SITE DEVELOPMENT PLANS FOR

LOT 14 PARKER POINTE PARKER, COLORADO 80134

Ziggis
COFFEE
PARKER, COLORADO

SHEET NAME
COVER SHEET

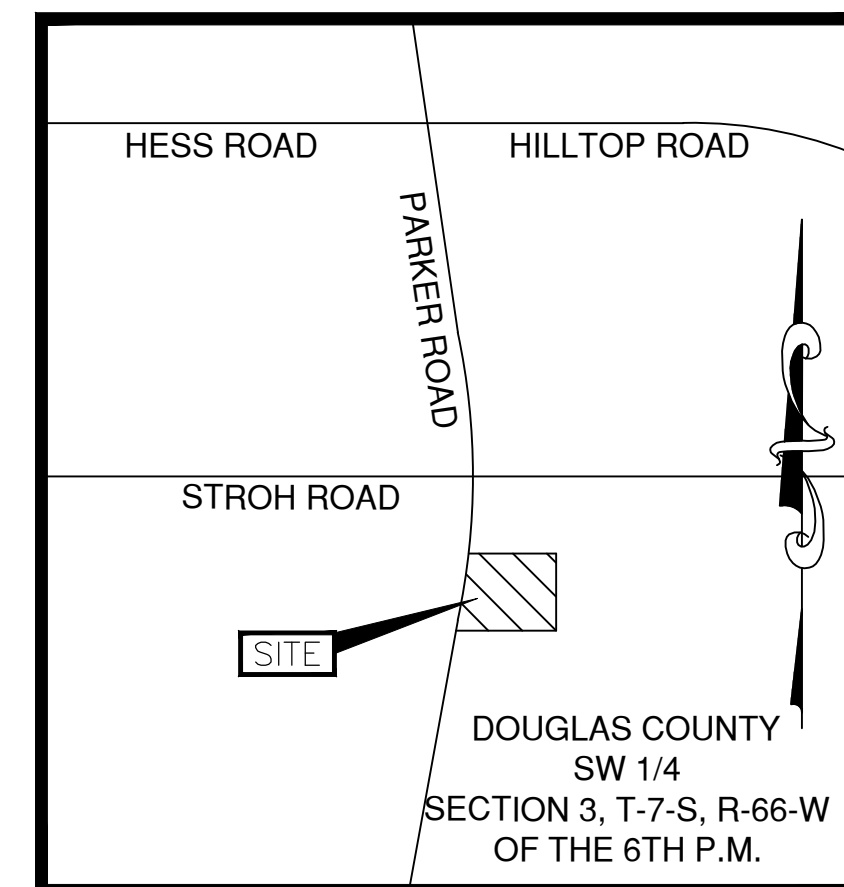
Please correct cross outs and revise sheet index

Please be sure to add revision dates

SHEET NAME
HORIZONTAL CONTROL PLAN

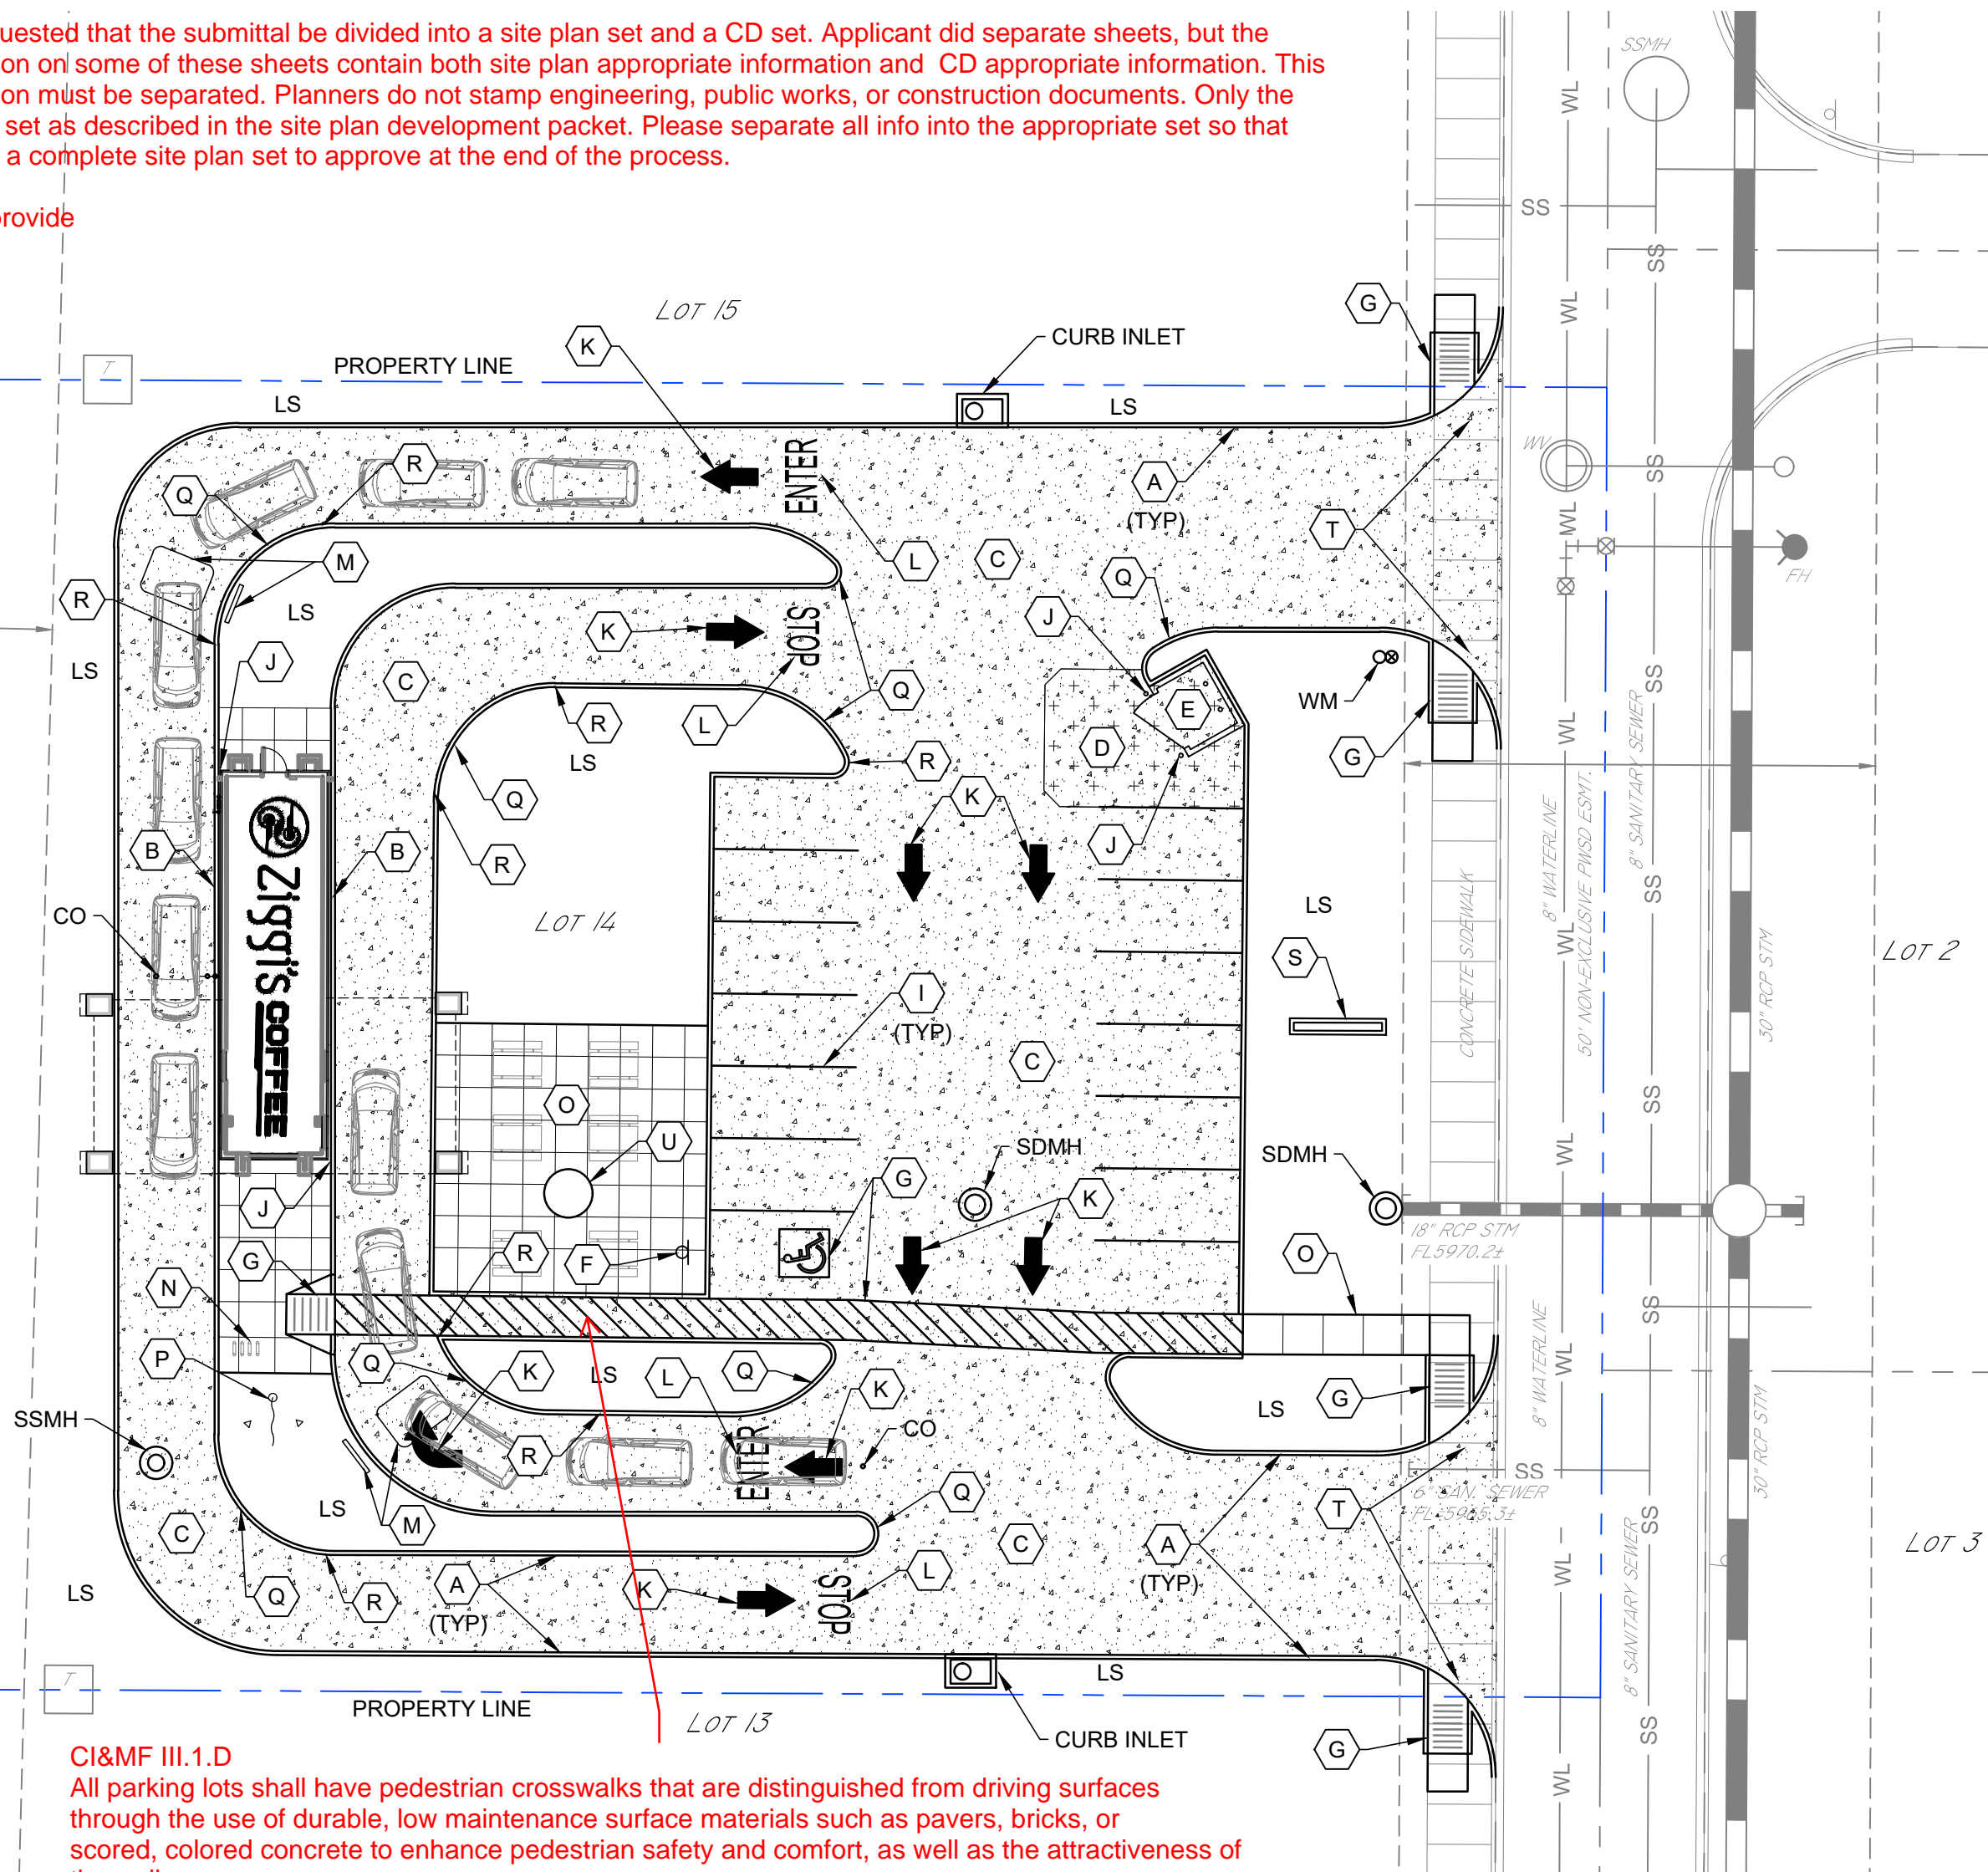
Staff requested that the submittal be divided into a site plan set and a CD set. Applicant did separate sheets, but the information on some of these sheets contain both site plan appropriate information and CD appropriate information. This information must be separated. Planners do not stamp engineering, public works, or construction documents. Only the site plan set as described in the site plan development packet. Please separate all info into the appropriate set so that staff has a complete site plan set to approve at the end of the process.

2 SIDEWALK JOINT DETAILS
SCALE: NOT TO SCALE

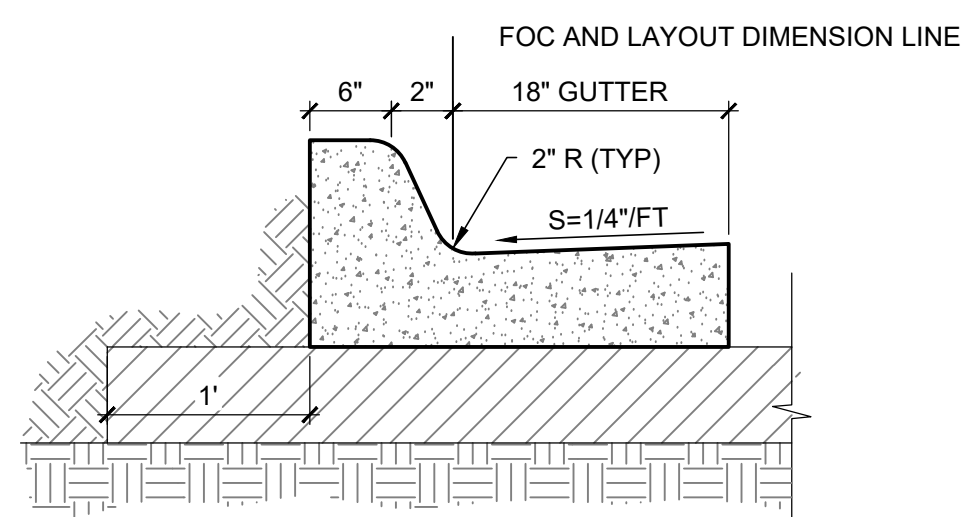
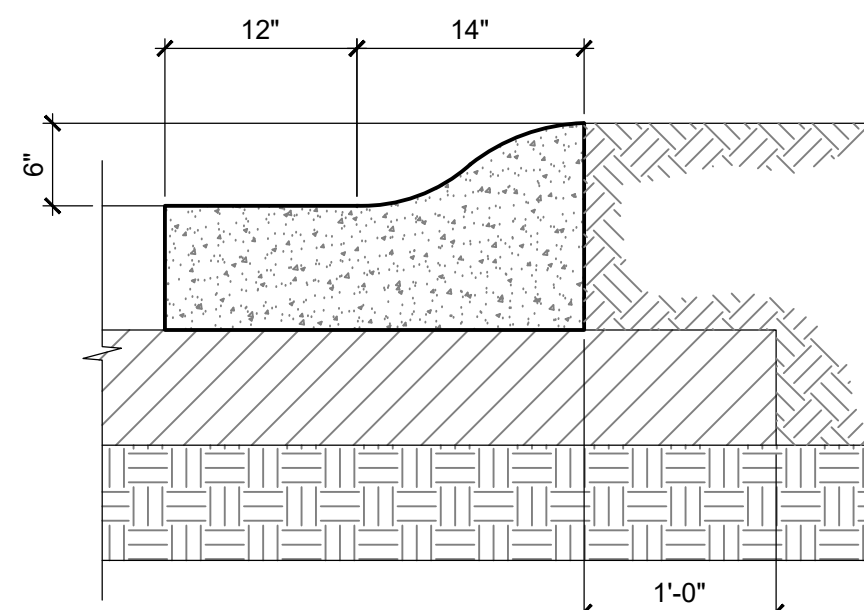
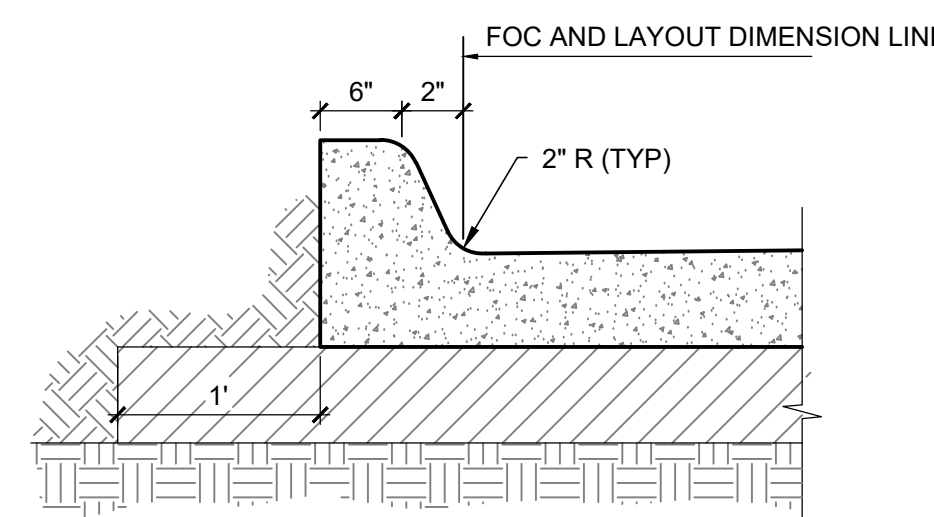
These details are not needed on the site plan, these are CD details.

1 SITE PLAN
SCALE: 1" = 20'

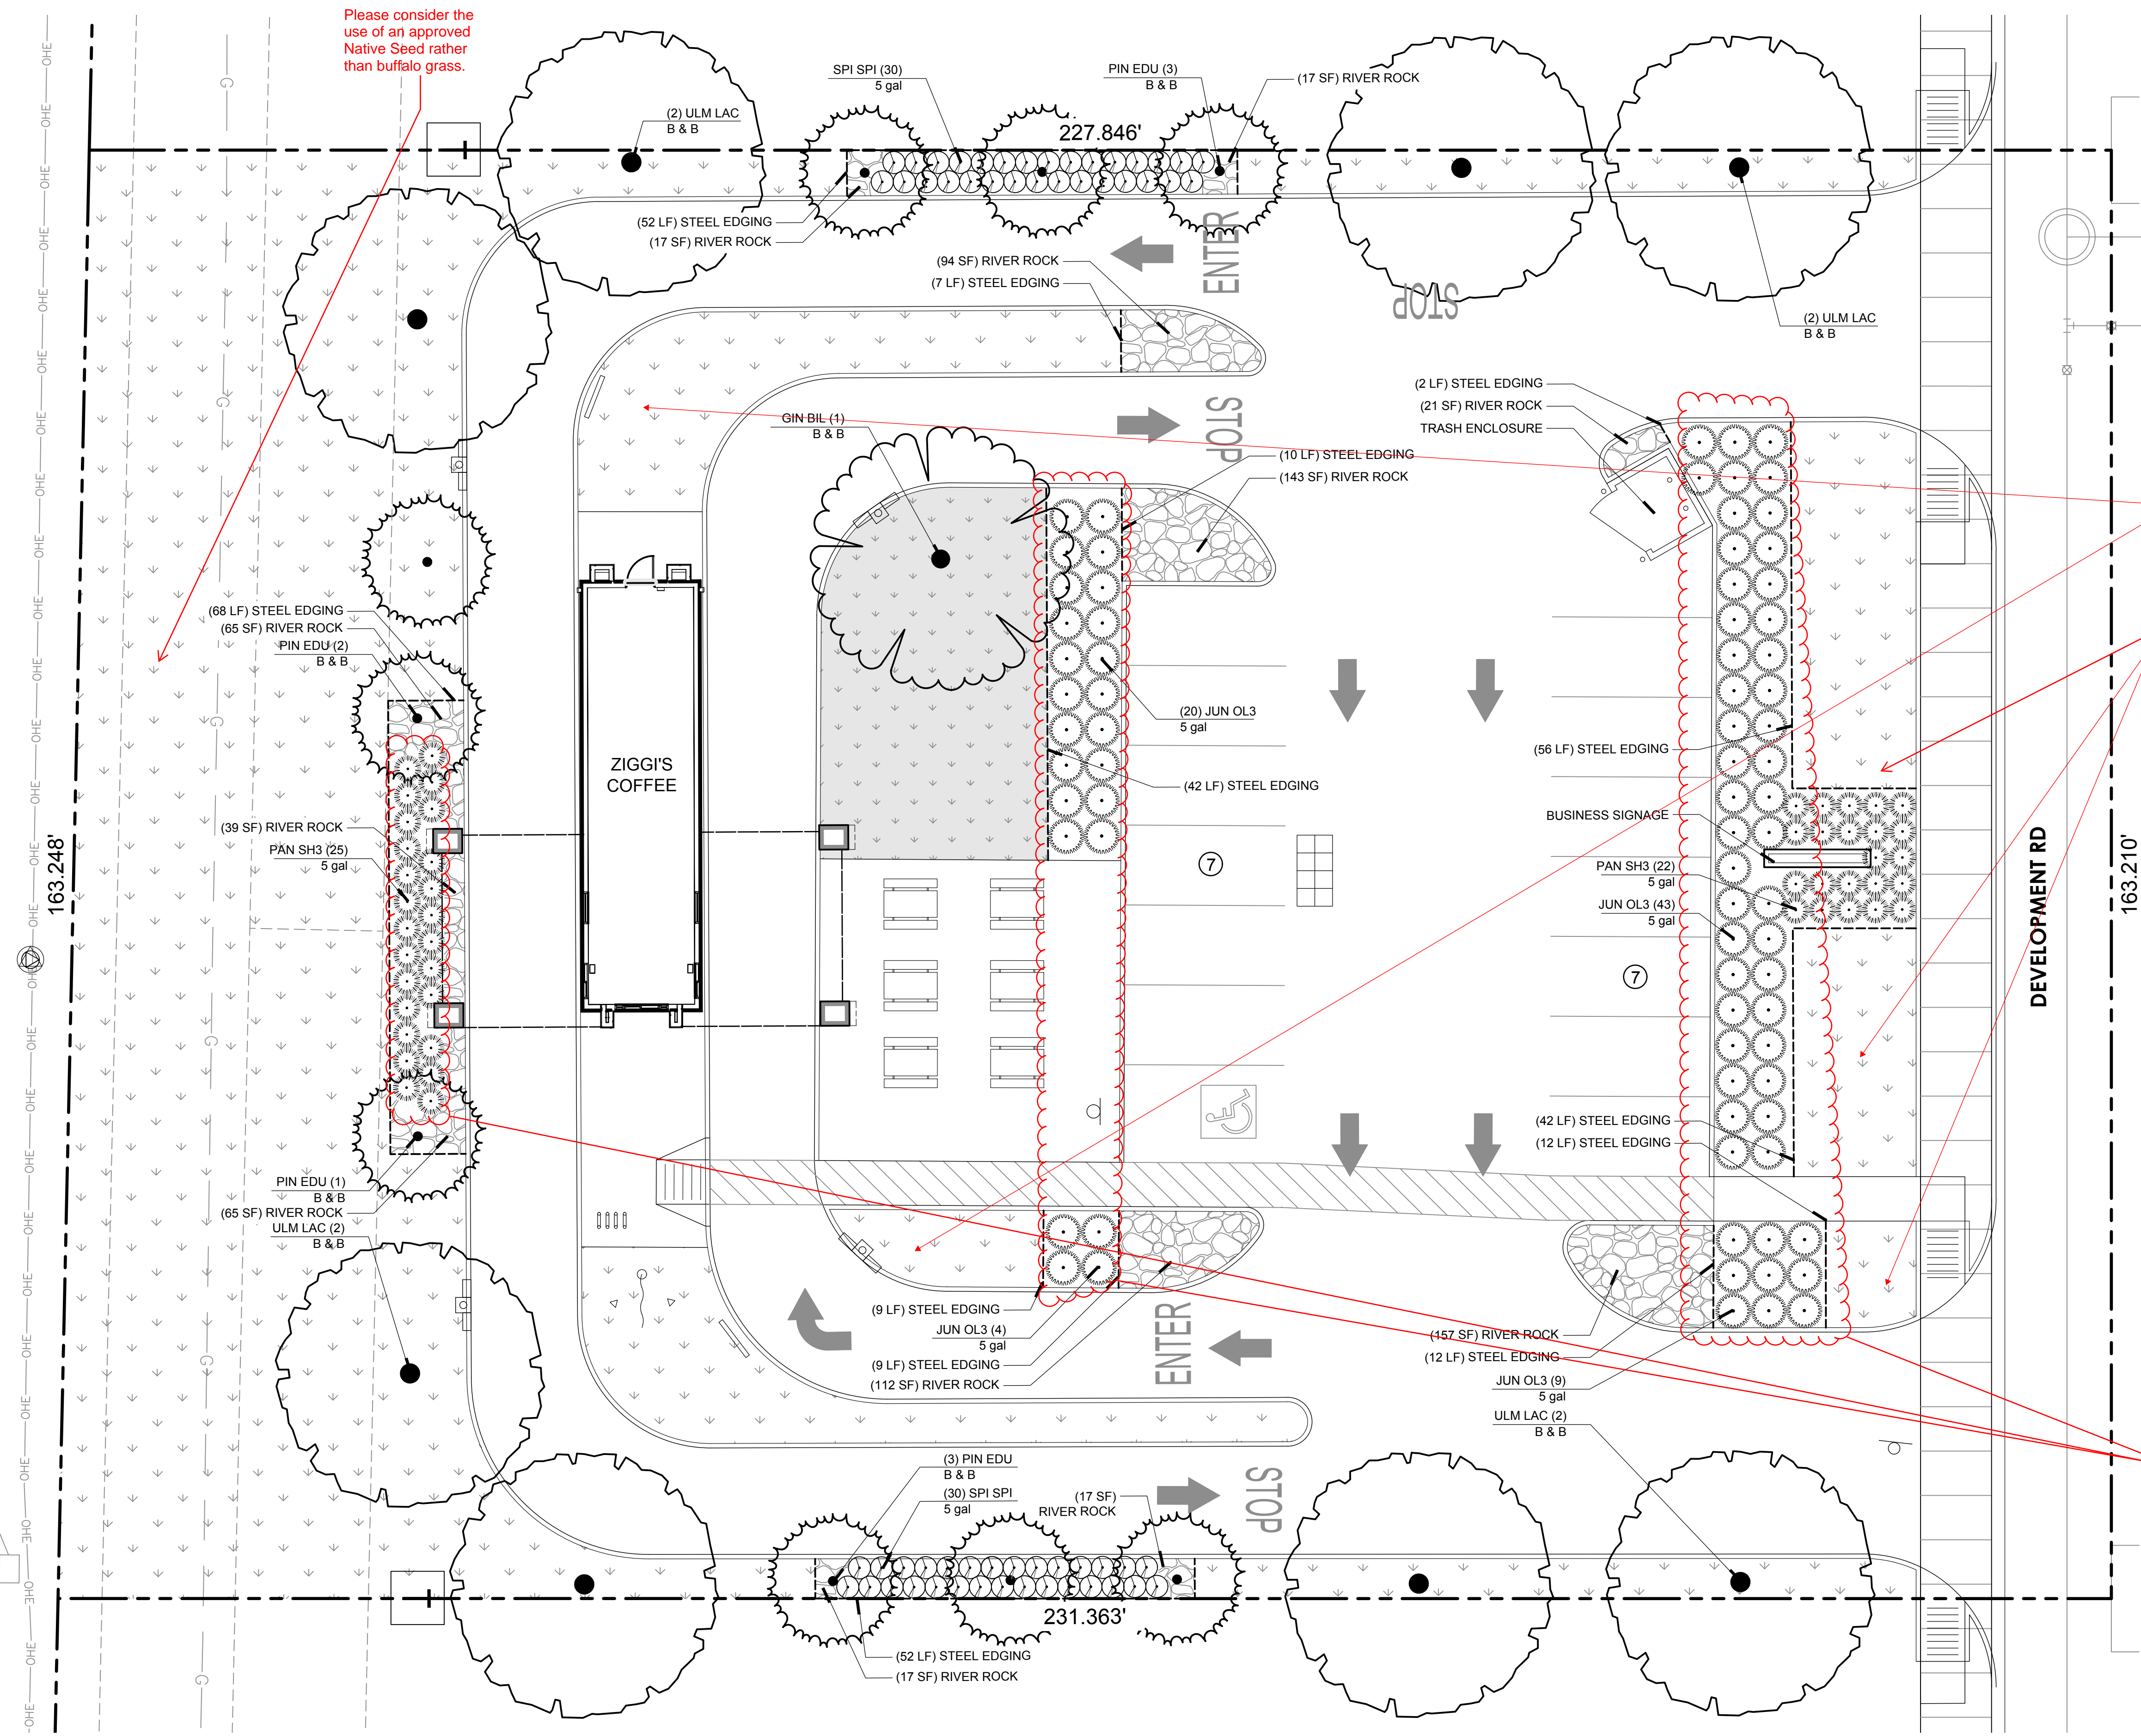
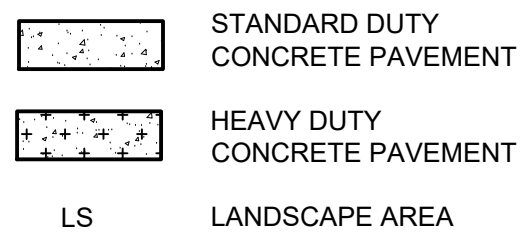
Please provide

CI&MF III.1.D
All parking lots shall have pedestrian crosswalks that are distinguished from driving surfaces through the use of durable, low maintenance surface materials such as pavers, bricks, or scored, colored concrete to enhance pedestrian safety and comfort, as well as the attractiveness of the walkways.

Scale is far too large for the site plan sheet, please enlarge by a minimum of 100%.

Please sort through these and remove those that belong in the CD's or on utility sheet or grading sheet.

Add bicycle parking to site criteria - Minimum 4

These notes are construction notes. These are not construction documents, this is a site plan set. Please review all notes for appropriateness as a part of the site plan set. Please review the site plan development packet for specific sheet requirements.
